AUTO FLIGHT - CAT IIIa AUTOLAND INSTALLATION

To install the autopilot rudder servo, and upload the Primus EPIC APM options to enable the Autoland function.

FIGURE 2 - AUTOLAND OPERATIONAL TEST CARD
(SHEET 01 OF 01)

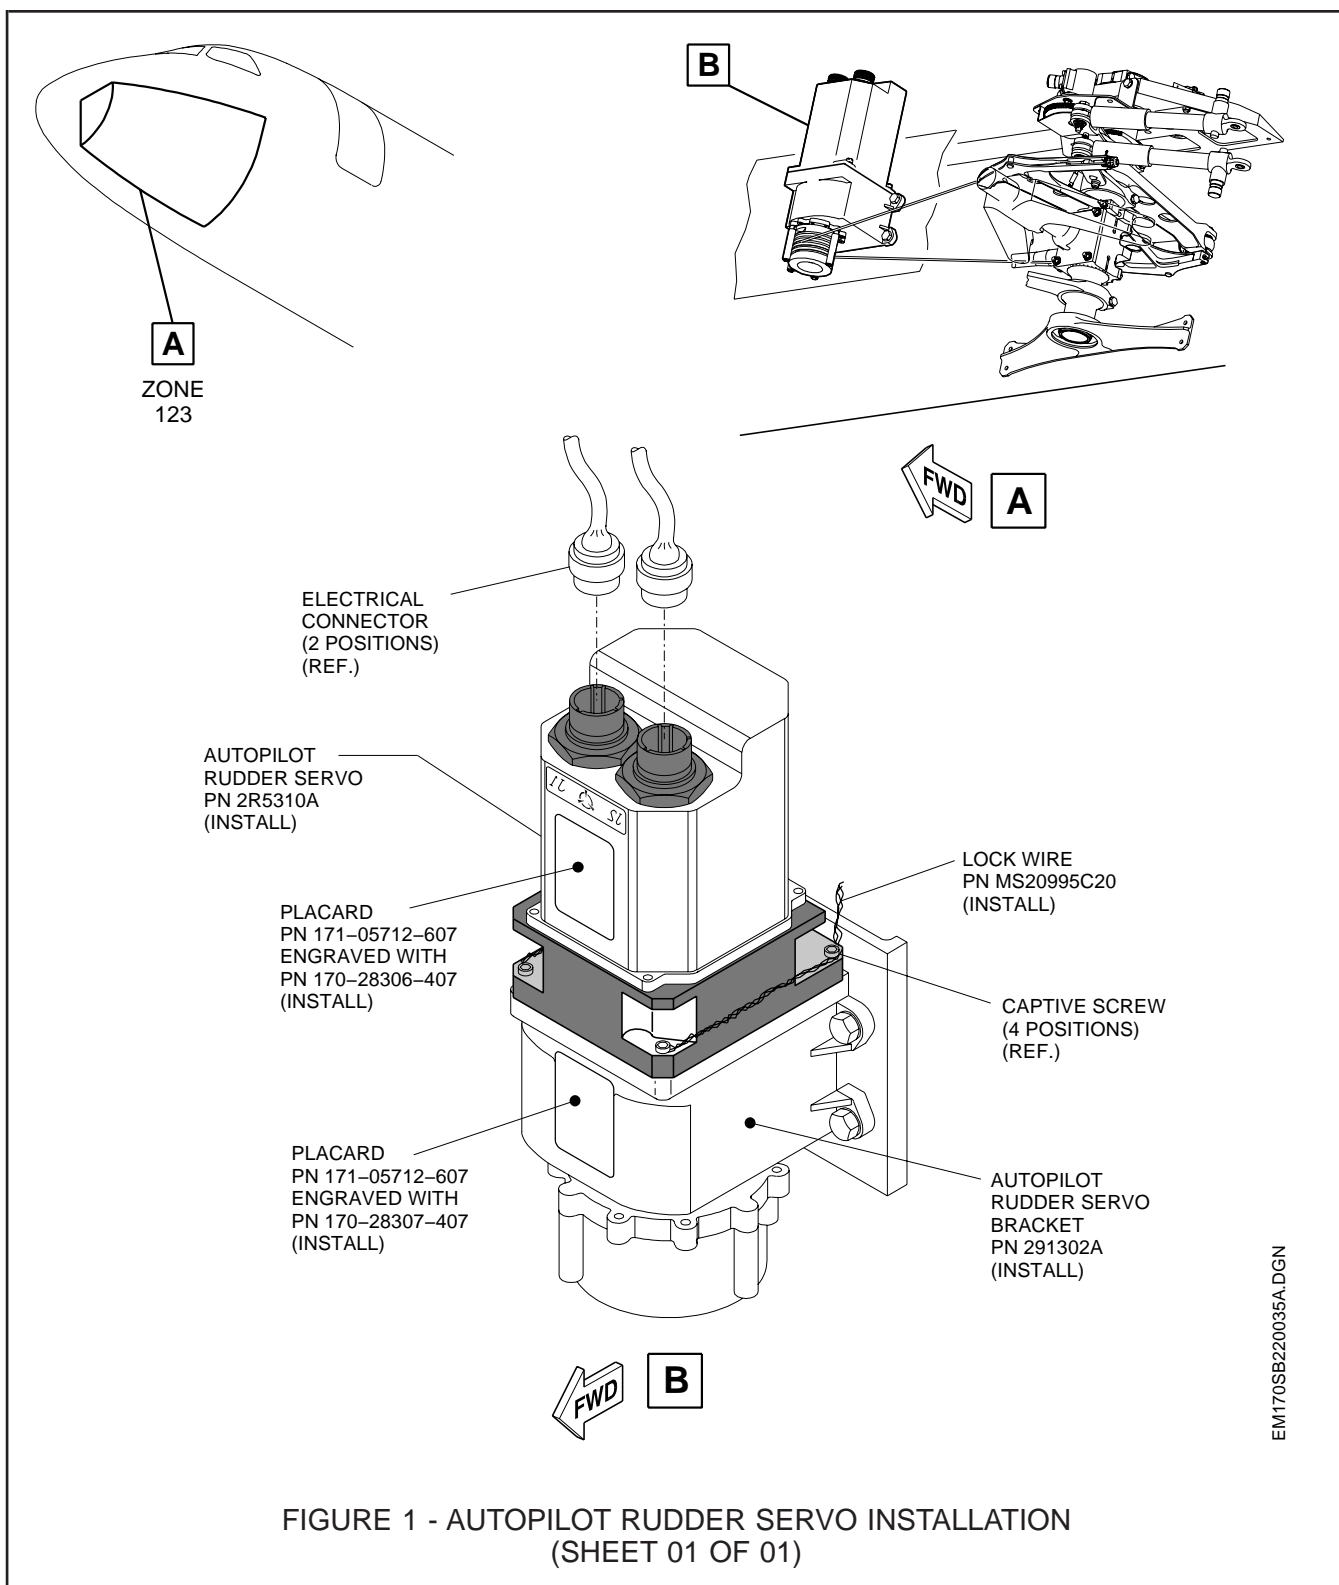
As a reference, a flight card is included to perform these check points. Refer to [Figure 2](#). In case the results of the verification flight are not approved, it is necessary to contact Embraer at the address given in [2.B. INDUSTRY SUPPORT INFORMATION](#).

IFR APPROACH – AUTOLAND APPROACH	
No associated EICAS messages	CHECK
Autoland ENABLED on the MCDU	CHECK
Landing Speeds on MCDU	PERFORM
A/P – ON	PERFORM
AT – ON	PERFORM
ILS frequency set on both MCDU	CHECK
Navigation Source – V/L	PERFORM
BARO / RA selector knob (both) – RA	PERFORM
DH (Decision Height) – 50ft	PERFORM
Final course on both PFDs – SET	CHECK
IFR approach procedure	PERFORM
Upon heading to intercept the localizer – F/D mode APP button – PRESS	FMA CHECK
Prior to FAF – Landing Configuration – ESTABLISH	PERFORM
AUTOLAND 1 armed on status Approach Annunciator	FMA CHECK
Rudder Trim zero	PERFORM
Upon localizer capture : F/D lateral mode – LOC	FMA CHECK
Upon glideslope capture : F/D vertical mode – GS	FMA CHECK
PFD select Speed – SET	PERFORM
Crossing 1500 ft AGL and configured to CAT III : AUTOLAND 1 active on Status Approach Annunciator	FMA CHECK
Rudder servo engages and is tested by commanding a slight movement of pedals in both directions	CHECK

ILS approach	PERFORM
Airplane normal Behavior	CHECK
Aural message : " APPROACH MINIMUMS "	CHECK
Aural message : " MINIMUMS"	CHECK
Aural message : " 50 ", "40 ", " 30 ", " 20 ", " 10 " on the appropriate height	CHECK
ALIGN on PFD at 150 ft	FMA CHECK
FLARE on PFD at 50 ft	FMA CHECK
RETARD on PFD at 30 ft	FMA CHECK
DROT/RLOUT on PFD after touchdown	FMA CHECK
Automatic A/P disconnection after 5 sec	CHECK
Airplane normal landing behavior	CHECK
Brakes – normal apply until stop	PERFORM
AFTER LANDING NORMAL PROCEDURES (AFM)	PERFORM
